# Service Bulletin

**Subject:** Rattle Noise from 2nd Row Outboard Seat Belt Retractor Latch Plate

Brand:	Model:	Model Year:		VIN:		Engine:	Transmission:
		from	to	from	to		
GMC	Acadia (VIN N)	2017	2017			All	All

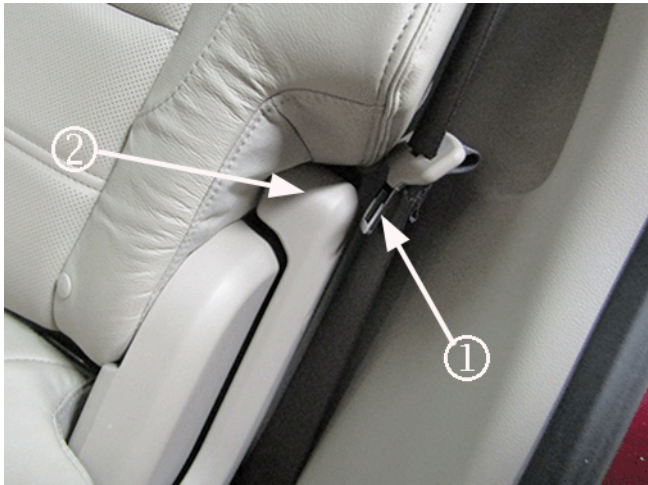
<b>Involved Region or Country</b>	North America, Middle East
<b>Condition</b>	Some customers may comment on hearing a rattle noise coming from the driver and/or passenger side 2nd row outboard seat belt retractor latch plate.
<b>Cause</b>	 <p>The cause of the condition may be that the latch plate (1) of the rear seat belt retractor is contacting the rear seat outer hinge finish cover (2).</p>
<b>Correction</b>	Apply flocking tape to both the driver and passenger side rear seat outer hinge finish covers, following the Service Procedure below.

Apply a short length of Kent Automotive\* BRS Tape P/N KT 13486, or equivalent flocking tape, to both the driver and passenger side rear seat outer hinge finish covers, at the location shown in the example graphic above.
